ORDINANCE NO. 03-10-5

An ordinance approving and authorizing the execution of Change Order No. One (1) - Final for Parish Project No. P011003, Willowdale Canal Erosion Control, to balance contractual quantities with actual job quantities.

CHANGE ORDER

Project Willowdale Canal Erosion Control

4. SCHEDULE OF PRICES
ST. CHARLES PARISH PROJECT NO. P011003

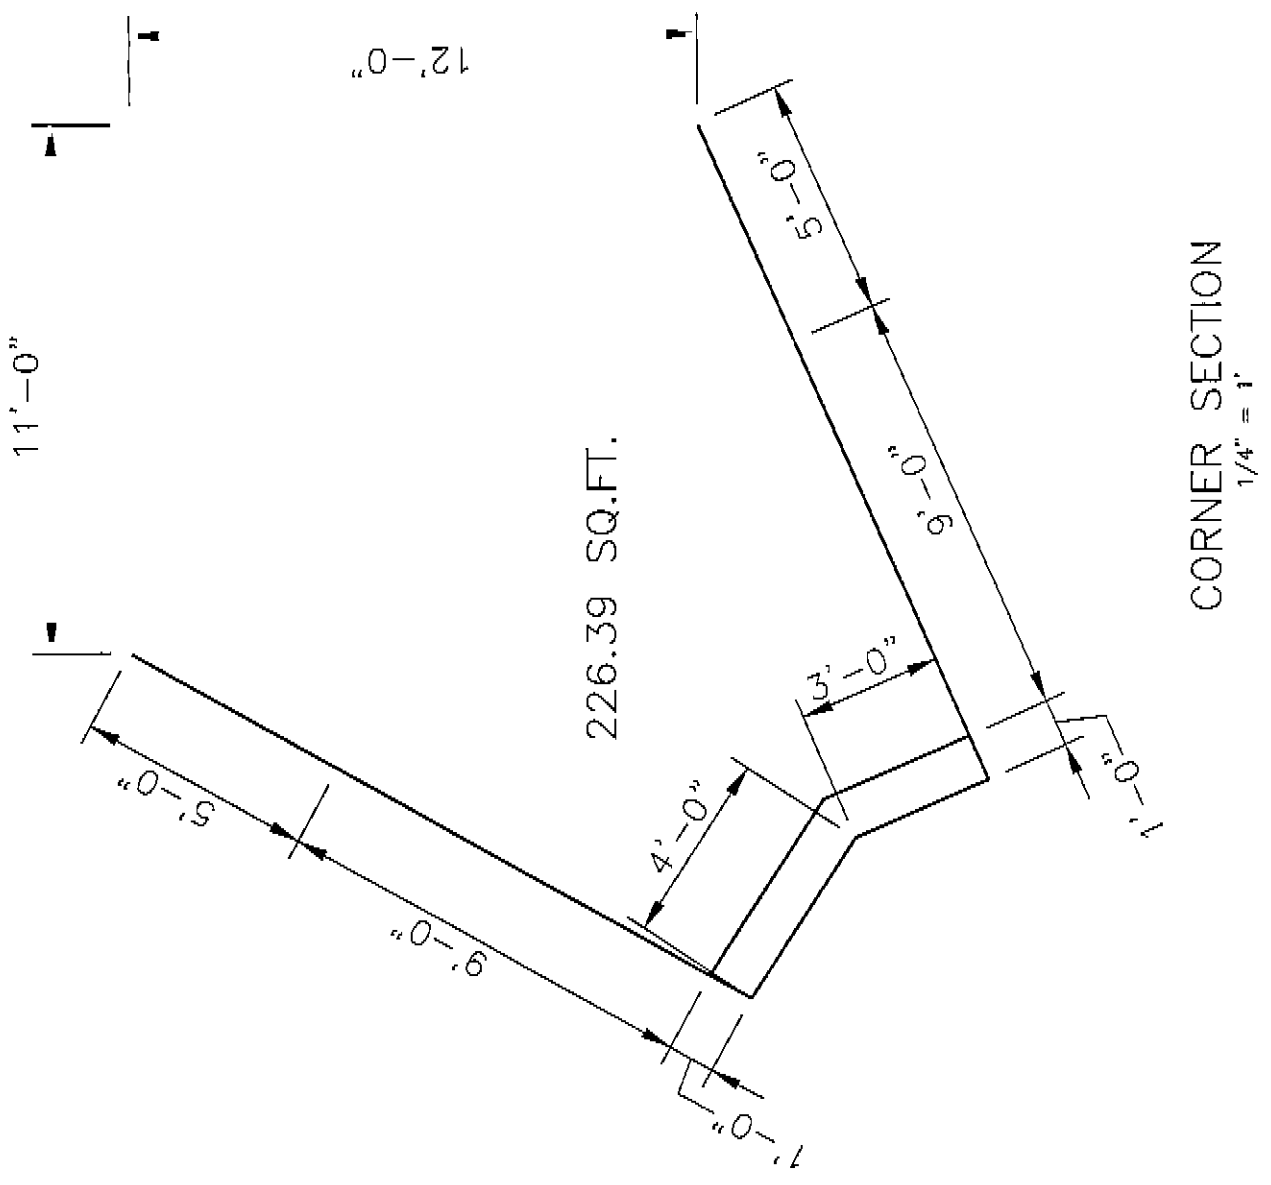
NO.	ITEM	UNIT	ESTIMATED QUANTITY	UNIT PRICE	TOTAL ESTI-MATED PRICE
1	Mobilization	1	Lump Sum	Thirteen thousand + $\frac{40}{100}$ Dollars & Cents	\$ 13,000.00 ✓
2	Clearing, Grubbing, Demolition and Scarification	3,627	Sq. Yds.	Seven + $\frac{45}{100}$ Dollars & Cents	+ 2,415.00 ✓
	<i>Add</i> 345 Sq. Yds				\$ 25,389.00 ✓
3	Cohesive Clay Fill (topsoil)	50	Cubic Yds.	7.00 Eight + $\frac{30}{100}$ Dollars & Cents	\$ 415.00 ✓
4	Class "A" Centipede Sod (Includes Sod Pins)	3000	Sq. Yds.	8.30 Three + $\frac{32}{100}$ Dollars & Cents	+ 2,447.60 ✓
	<i>Add</i> 737.23 Sq. Yds				\$ 9,960.00 ✓
5	Reinforced Concrete Slope 870 Pavement	Sq. Yds.		3.32 Seventy-five + $\frac{82}{100}$ Dollars & Cents	+ 5,672.94 ✓
	<i>Add</i> 1482 Sq. Yds				\$ 65,963.40 ✓
6	Splash Blocks	20	Ea.	Three hundred thirty + $\frac{40}{100}$ Dollars & Cents	- 1,650.00 ✓
	<i>Delete</i> 5 ea.				\$ 6,600.00 ✓
7	Relocation of Infrastructure Items	Allow		Ten Thousand Dollars & No Cents	- 10,000 ✓

<i>Delete</i> 1				(\$10,000.00) \$10,000.00 ✓

Total of all Estimated Prices: (\$ 131,327.40 *Revised* (\$ 130,217.94)
One hundred thirty-one thousand three hundred twenty-seven + $\frac{40}{100}$ Dollars.

~~\$~~ - 1,114.46

LOT 157 $\left[15.5' \times 150' = 2325 \text{ S.F.} \right]$
 $\frac{1}{2}'' = 1'$

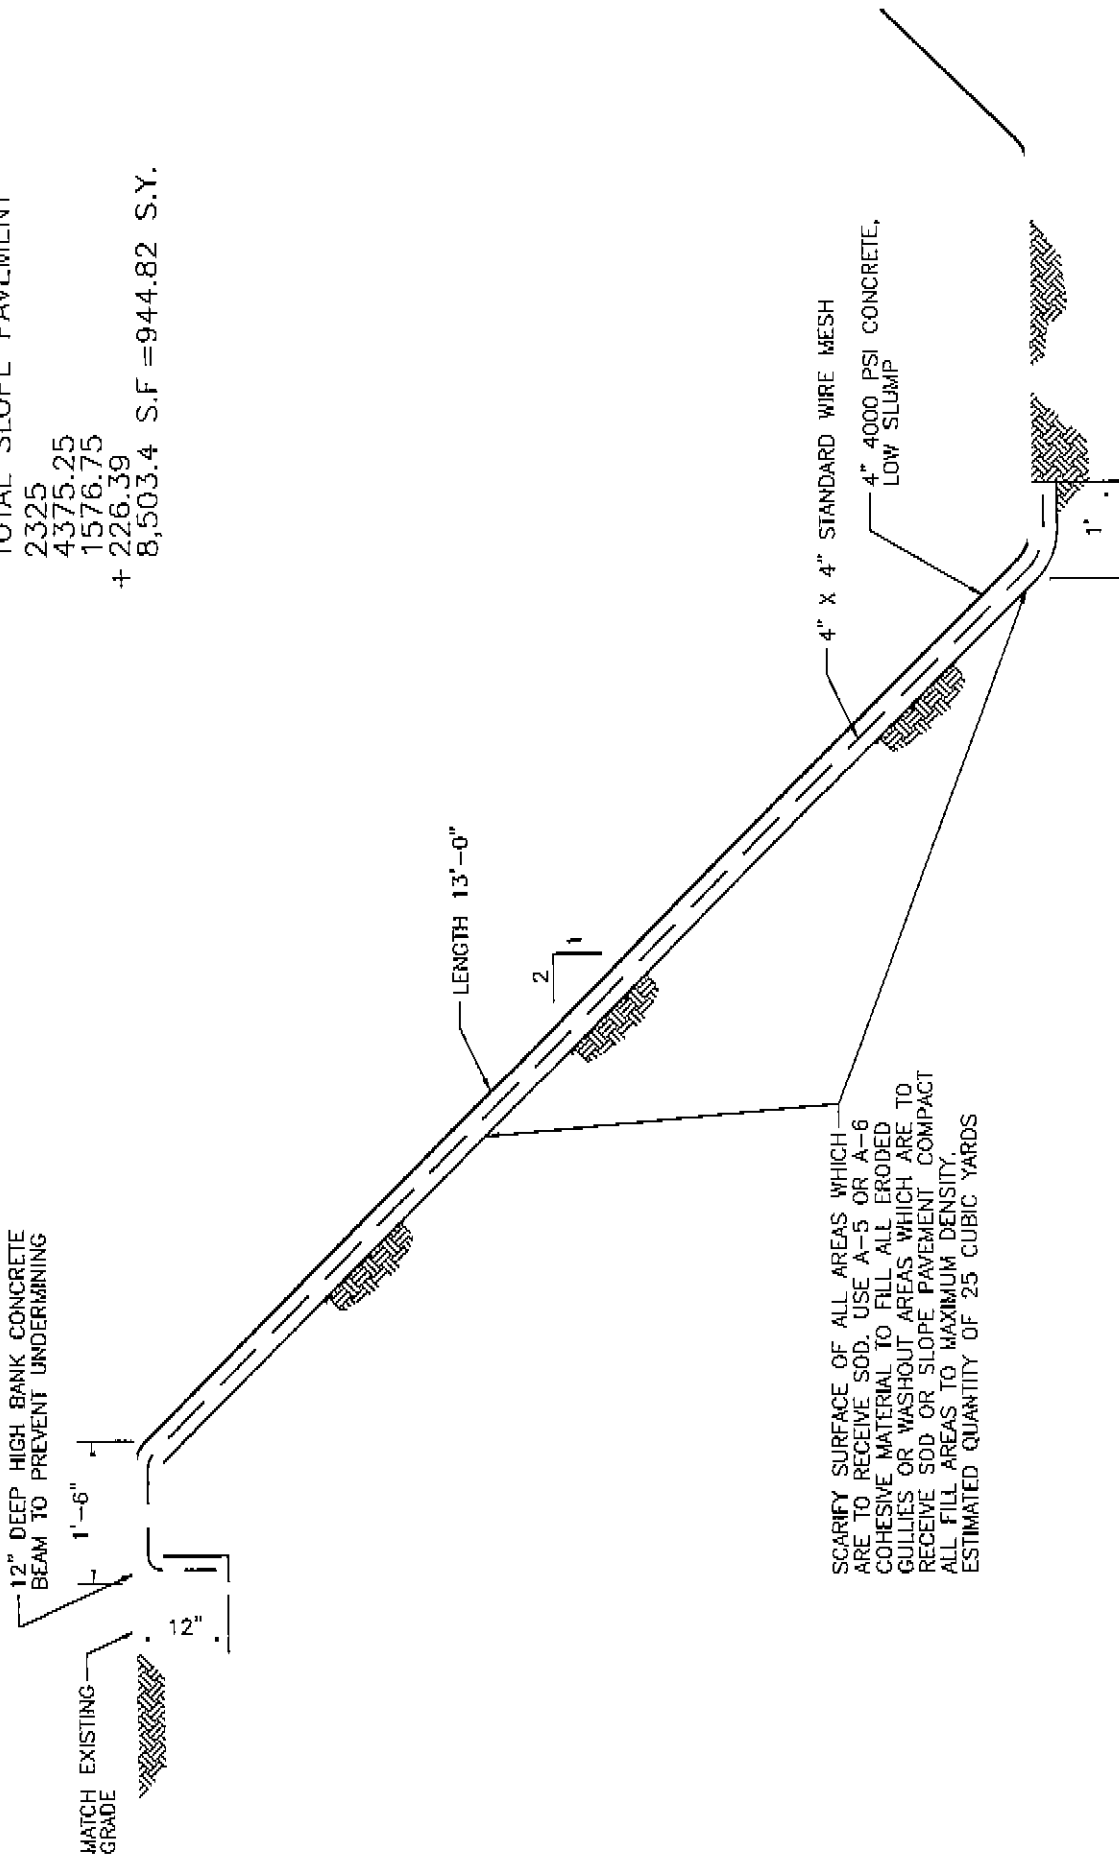
TOTAL SLOPE PAVEMENT
 2325
 4375.25
 1576.75
 + 226.39
 8,503.4 S.F.=944.82 S.Y.

CORNER SECTION
 1/4" = 1'

LOT 159 (SOUTH SIDE)
 $\frac{1}{2}'' = 1'$

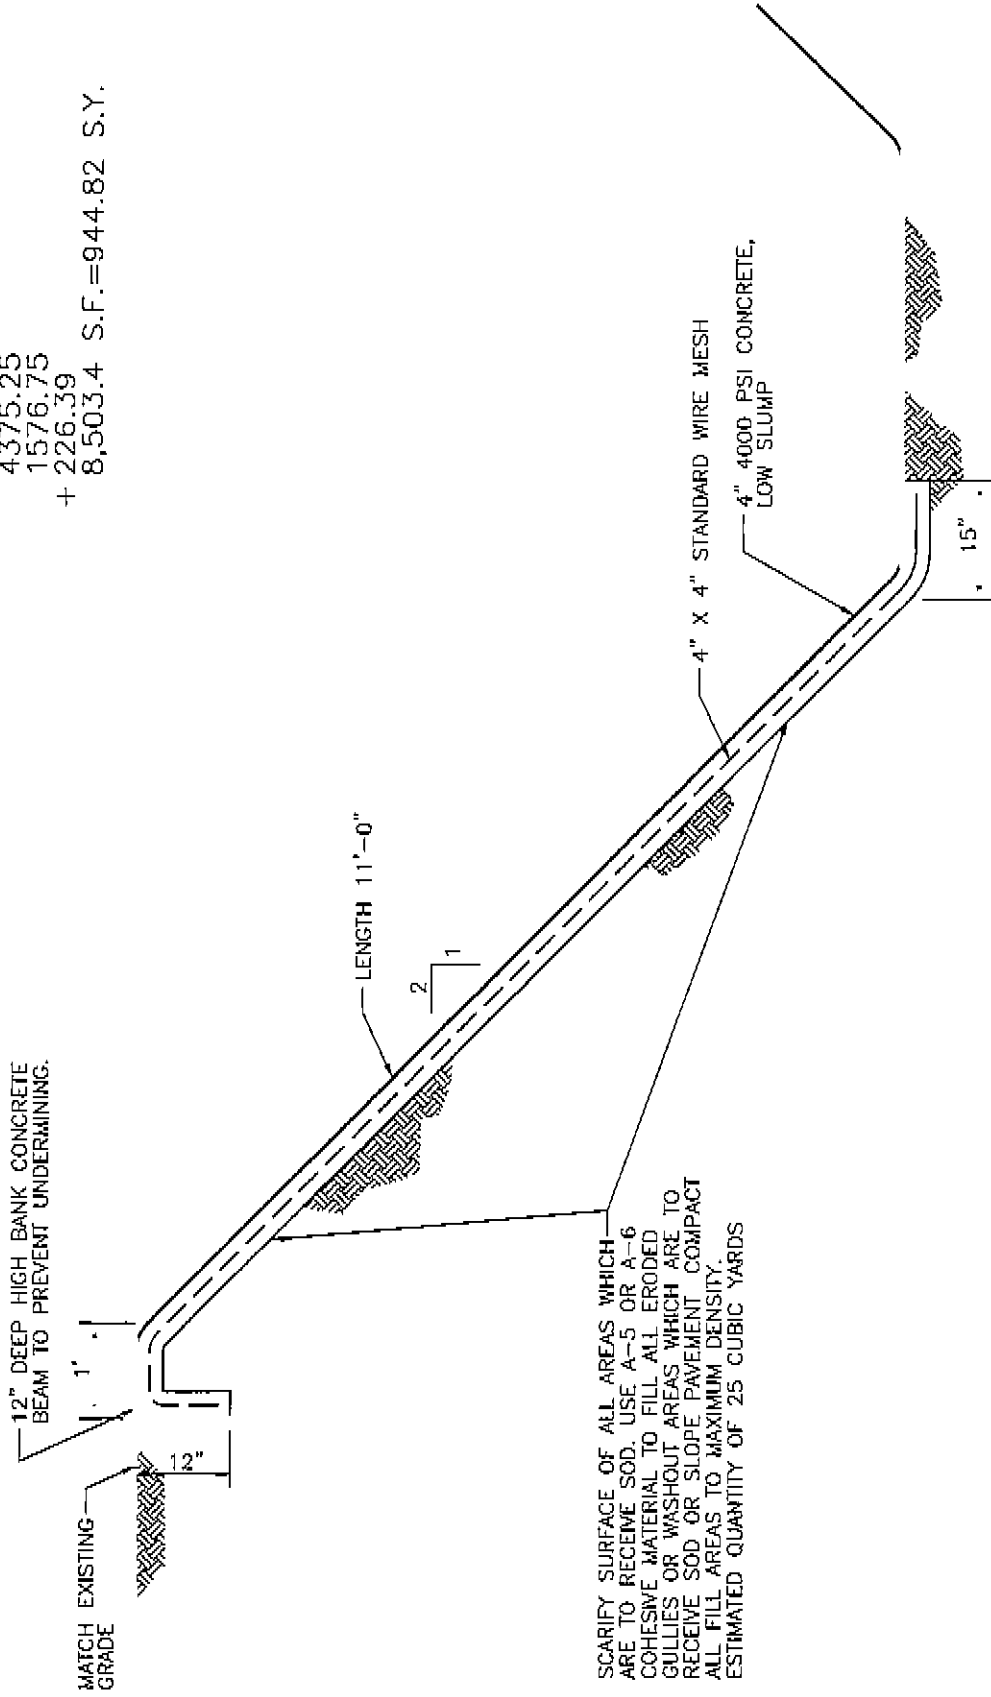
$13.25' \times 119' = 1,576.75 \text{ S.F.}$

LOT 159 (WEST SIDE)
 $\frac{1}{2}'' = 1'$

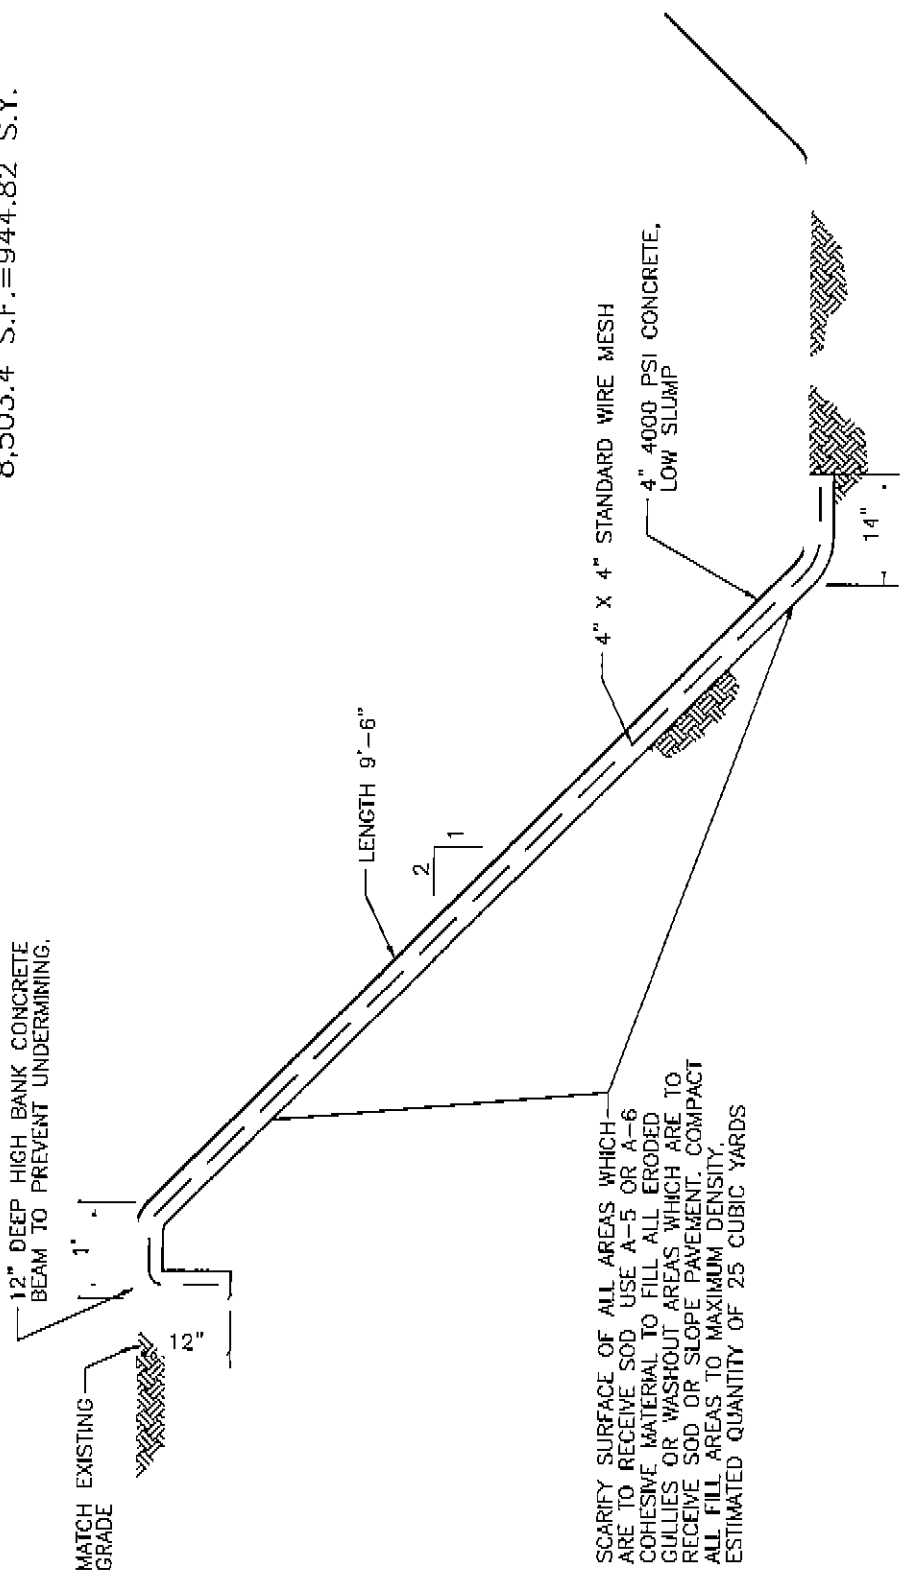
$11.67' \times 375' = 4,375.25 \text{ S.F.}$
